DECLARATION

Wireless DoorBell (model name: Bell 1S, Bell 1S_DC. FCC ID: 2AG7C-BELL1S).

Bell 1S and Bell 1S_DC are designed based on the same product, only slight differences between them. Bell 1S has been tested by BACL.

Bell 1S

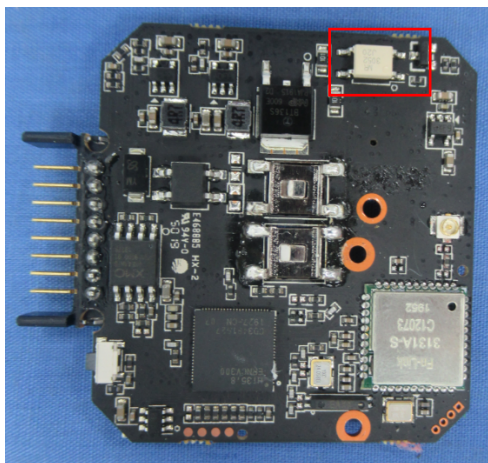
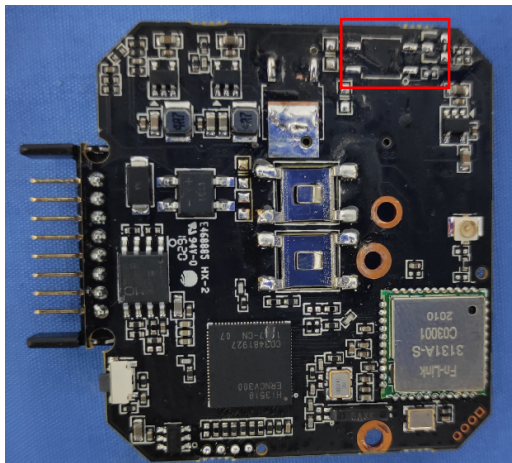
1. Model name.
2. Bell 1S_DC has fewer components than Bell 1S (these components(highlighted in red) control the mechanical bell, which doesn't affect the RF performance, so the radio parameters of them are the same). Please check the photo as below:
